SERVICE BULLETIN: JSB 016-1

Subject: J160 Family Engine Cooling

All Jabiru J160 family aircraft (All J160 & J170 models)

Figures 2 – Small Cowl Lip

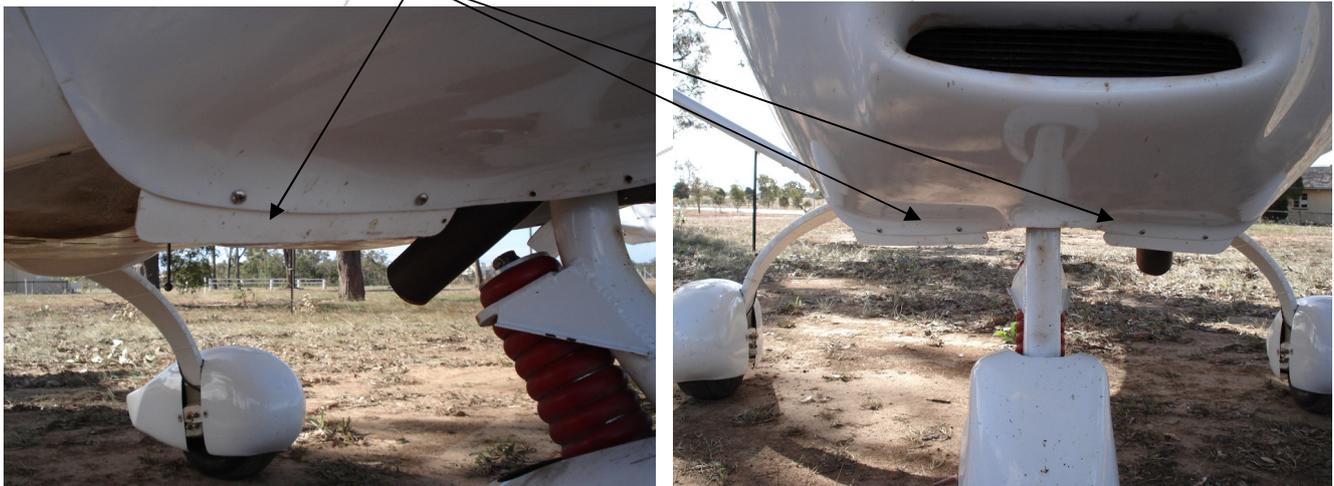
A fixed lip added to the lower cowl opening significantly improves cowl airflow. The examples shown in Figures 2 are made from fibreglass sheet and have been attached using self-tapping screws – though other materials & methods of attachment are acceptable – i.e. 0.050" thick aluminium sheet or 0.5mm stainless steel sheet. Rivets or adhesives may also be used for attachment. The lips added should be angled at approximately 40° to 60° to the level datum of the aircraft.

Lips 150mm laterally by 50mm wide. Project 25mm min past end of original cowl lip.

Figure 4 – Cross Section View Through Large Cowl Lip Attachment

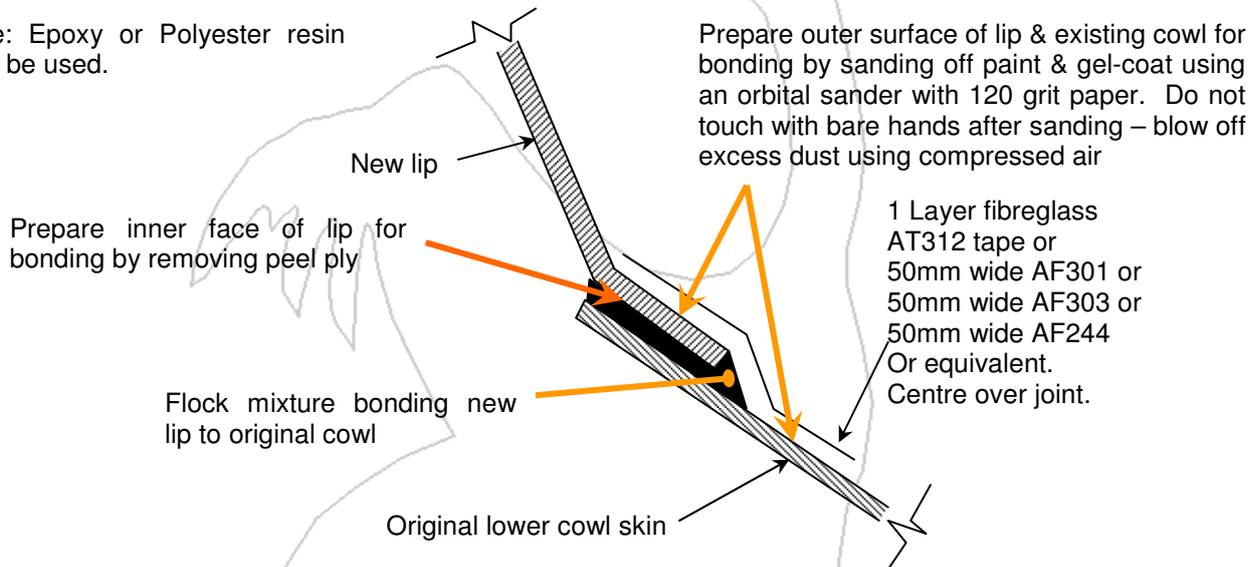
The fixed lip shown in Figures 5 is available from Jabiru Aircraft. To fit, the lip is centred on the cowl with its rearmost tips touching the rear of the cowl opening. The shape of the inside of the lip is marked out on the cowl, and the section of the cowl beyond aft of the line is cut out. The lip is then permanently attached using adhesive & a layer of fibreglass. Note that the smoothness of the transition between the original cowl and the new lip affects the efficiency of the airflow, so the newly-cut edges must be sanded to remove any rough or sharp edges.

Note: Epoxy or Polyester resin may be used.

Note: Figure 4 is shown with cowl sitting **upside down** (as shown in Figures 5 below).
